WORK DESCRIPTION FOR FIELD MEASURE

Code: 24P6392004

Rework side wall on longitudinal member on right and left

Model 236

Figure 1

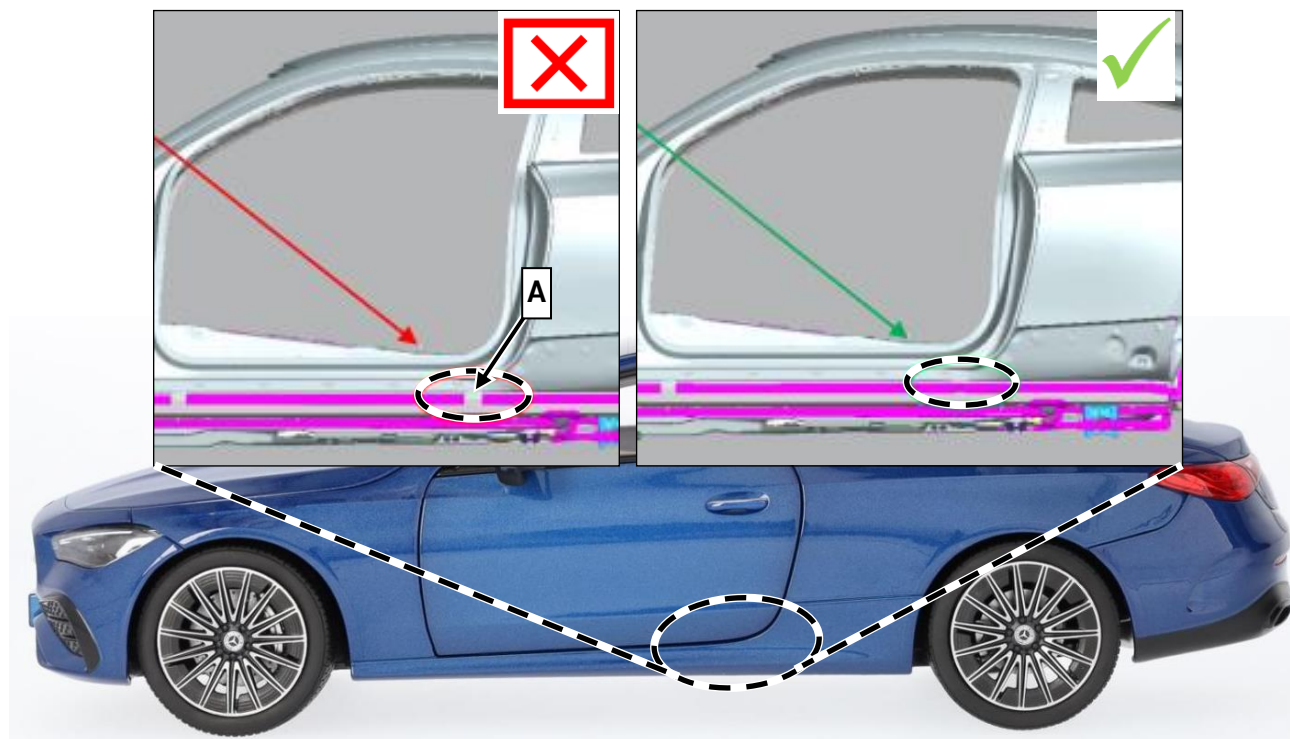
1. Remove longitudinal member panel on **right** and **left**.
 For basic data, see AR88.80-P-6000WEB.
2. Clean affected area (A, Figure 1) and treat with activator. Then seal with transparent seam seal.
 Rework seam seal **only** in affected area (A, Figure 1) on **right** and **left** sides.
